STORMWATER MANAGEMENT COMMISSION

Meeting Minutes

Location: Brookside Subdivision, Unincorporated Gurnee, Lake County, IL

Topic: Resident concern about stormwater/changes to drainage within subdivision

Attachment 1

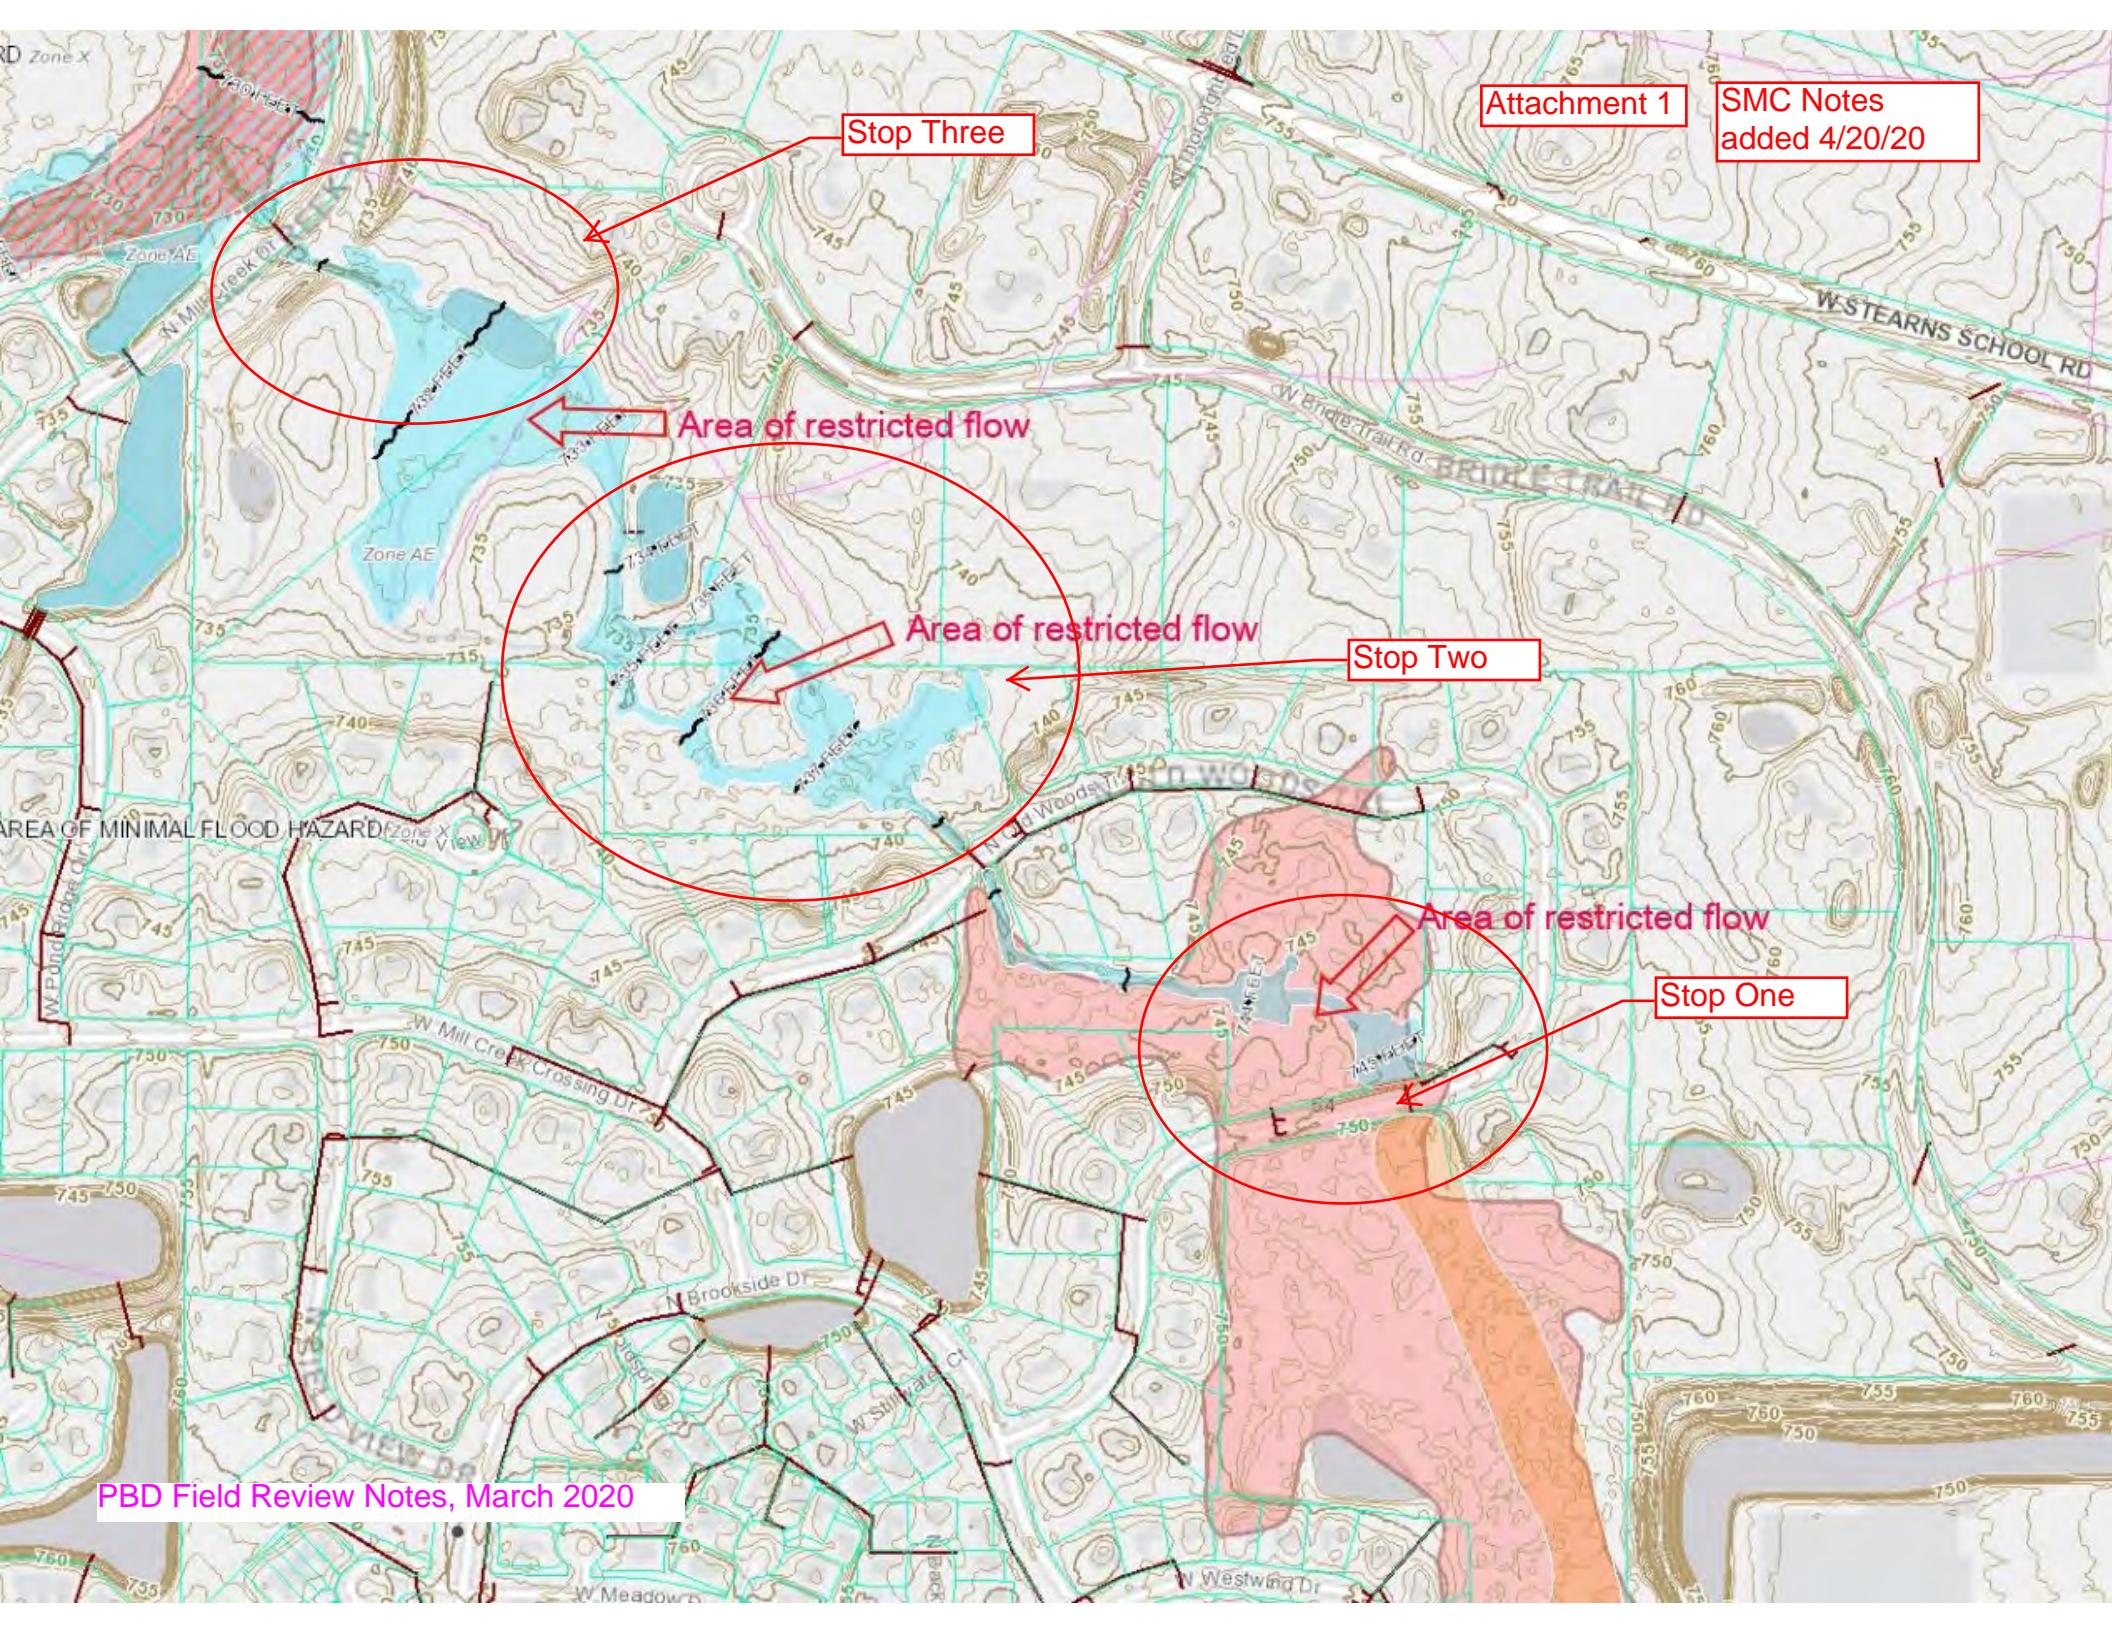
The diagram below illustrates the drainage path for the Brookside subdivision, which is on the north side of Grand Ave. west of Hunt Club Rd. There are 4 areas of concern labeled A, B, C and D in the diagram. A represents the drain for the neighborhood while B, C and D represent external water sources.

This is the drain for Brookside. It eventually flows into Mill Creek. Where the creek crosses the boundary between Brookside and Hunt Club Farms, which happens to include a bridle path, the creek appears to be obstructed on Hunt Club Farms property. This has caused the wooded area on the Brookside property to become much wetter, killing the trees which grow naturally. In approximately 1990 during the construction period, the creek was moved and a pond created on the Hunt Club Farms property. See the aerial photos below for a 1980 vs. 1993 comparison.

Area A North of Brookside in 1980

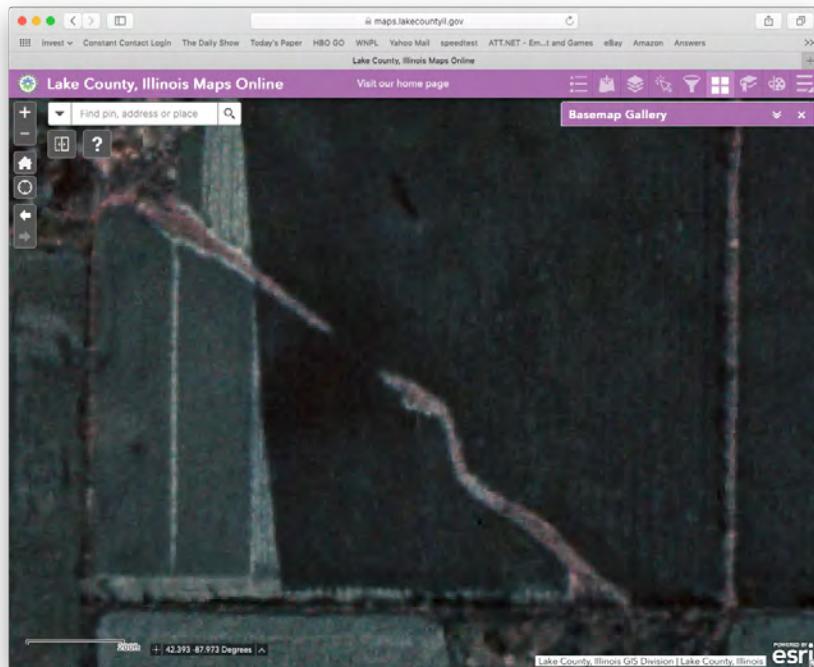
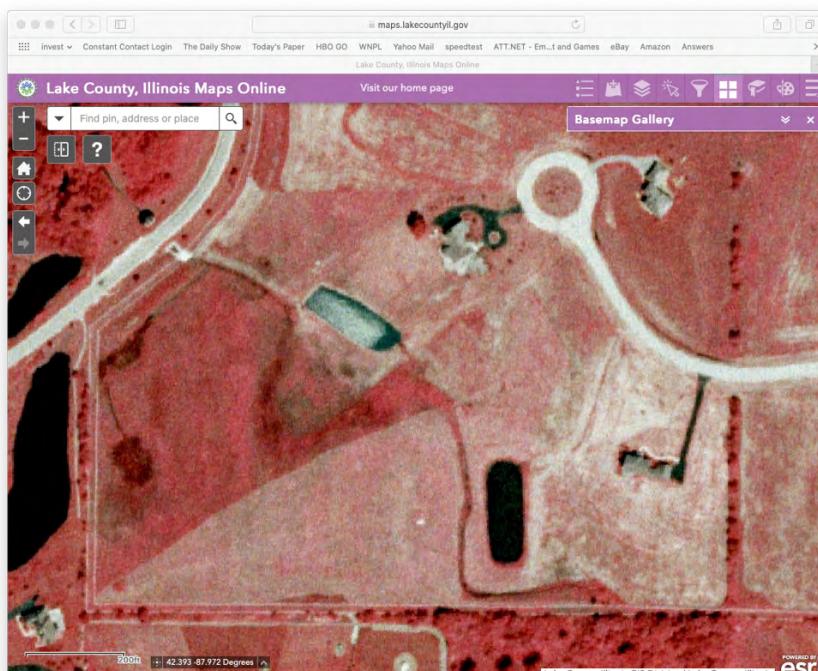
The creek from 1993 follows the property line and has contributed to wetland expansion on both sides of the property line.

- Diversion of an established creek around the newly created pond probably needed a permit. Was a permit issued?
- The second pond in which the creek flows has had a dam built to raise the water level in the pond. This has caused a backup of water in the area of the property line. The dam needs to be removed.
- A few years ago, new pipes were installed under the bridle path where it parallels N. Mill Creek Dr. Which contractor did that work and who approved it?

ACTION: PBD to review files and aerials to determine if the pond has been intentionally enlarged (there also should be permits on file from PBD & the US Army Corps for installing the rip rap and fabric). [PBD 4/20/20: Attachment 4 provides a series of aerials regarding Jim's (HOA) concern with the downstream pond in Hunt Club Farms. I do not see evidence that this pond is being held to a higher water surface elevation than in the past. I do notice that the turf grass side of this pond is experiencing erosion while the unmanicured side is holding in place.]

Brookside Master Association
Hunt Club Farms Creek Obstruction Report

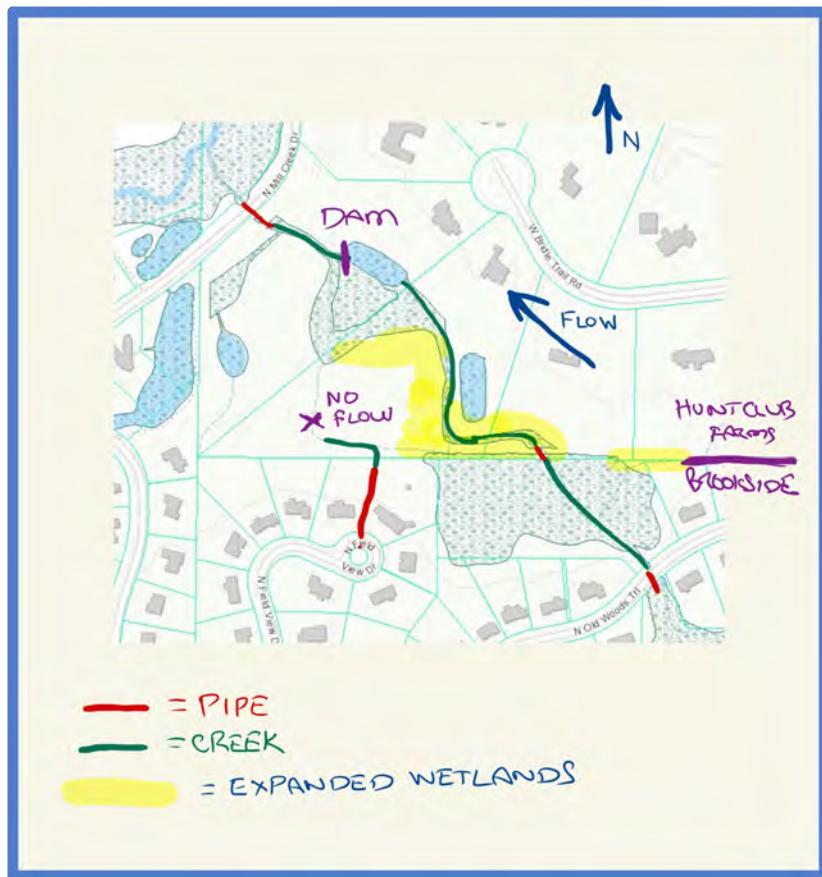
An obstruction has been built at the west end of the pond in the drainage path for Brookside. This obstruction raises the level of the water in the pond by 12-18 inches. In turn, the wetland area has expanded and has resulted in flooded land even during dry periods. Riprap was added to the pond shoreline at some point. It is now submerged. The obstruction must be removed and the original pond level restored.

Brookside Drive and Field View Drive drain through storm sewers and a culvert to the area marked NO FLOW. At one time this flow would have made it to Mill Creek, but no longer does. The water pools on the bridle path north of Brookside. This creek needs to be re-established. Once the obstruction is removed it could be connected to the main drainage creek.
